Public Service Company of Colorado

August 20, 1979
Fort St. Vrain
Unit No. 1
P-79181

Subject: Fluctuation Testing
Reference: P-79094
P-79131

GA RT -500 Revision F

FIG. 1. REQUIRED MARGIN ON ALLOWABLE MISMATCH
(L.C.O. 4.1.7 LIMIT - TEXT)

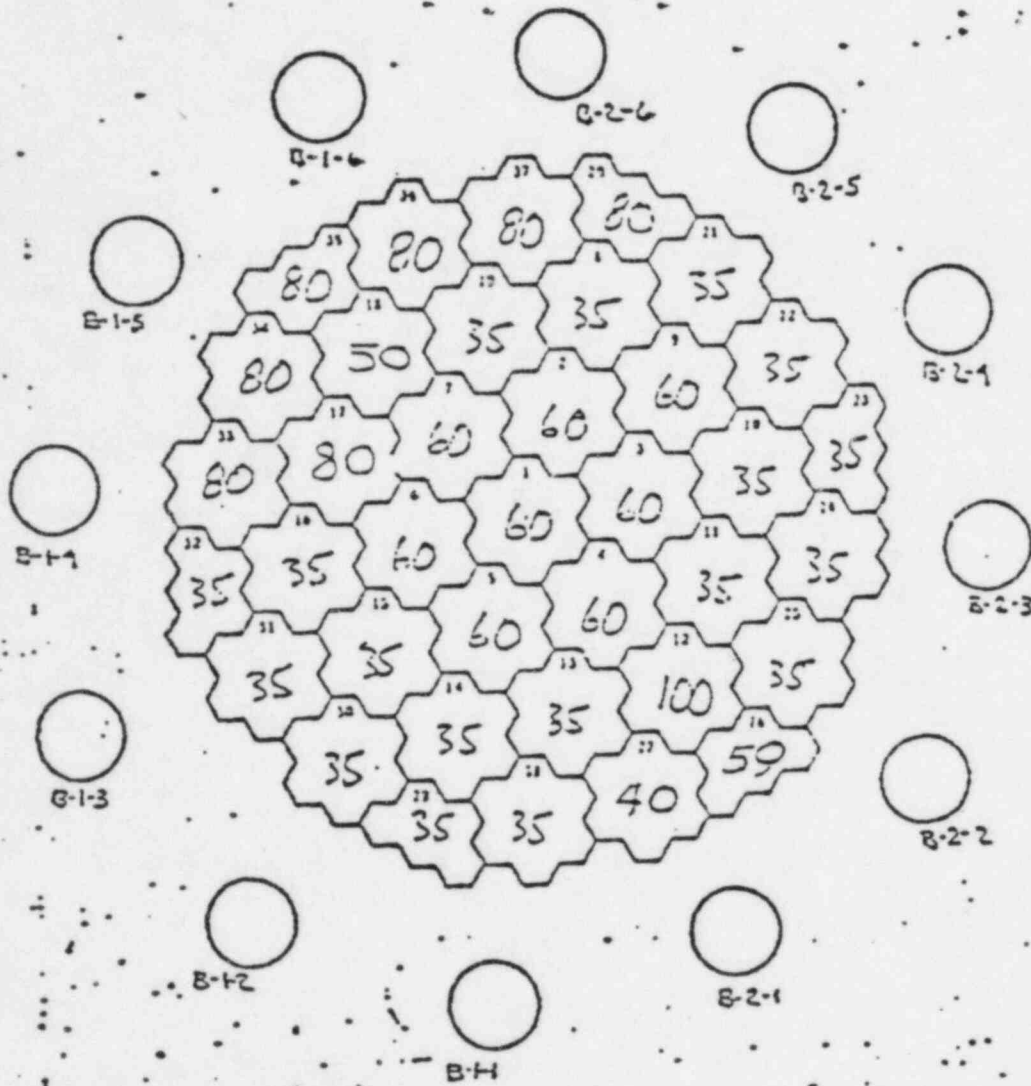
Under Operating Considerations (Sheets 5 and 6 of RT-500), it is not likely that the changes in region outlet temperature experienced during cycle 1 provide a good basis for the Figure 1 limits on cycle 2. Your note indicates that Figure 1 will be administratively revised based on cycle 2 experience. The staff should be consulted on changes to Figure 1 or a more general limitation should be defined in RT-500.

It was pointed out in the meeting of August 16, that Figure 1 represented our best estimate of temperature margins. These margins were necessarily based on cycle 1 as there is no other basis for the estimate. In addition the margins established, while they only represent a starting point, are necessary in order to obtain a core temperature outlet configuration that will keep us within Technical Specification limits.

It was agreed that PSC would keep the staff informed of changes to Figure 1, as well as other significant test procedure changes. PSC would intend to notify the staff of significant procedural changes or the intent to revise procedures when the summary test data is furnished (see attachment to P-79131). The summary test data will be submitted to the staff within one (1) week of completion of testing for each power level.

E NOTE: The margins per Figure 1 are based on cycle 1 experience. When fluctuations are observed in cycle 2, the regions that exhibit the largest temperature variations may be different. As differences, if any, are observed, Figure 1 will be administratively revised accordingly.
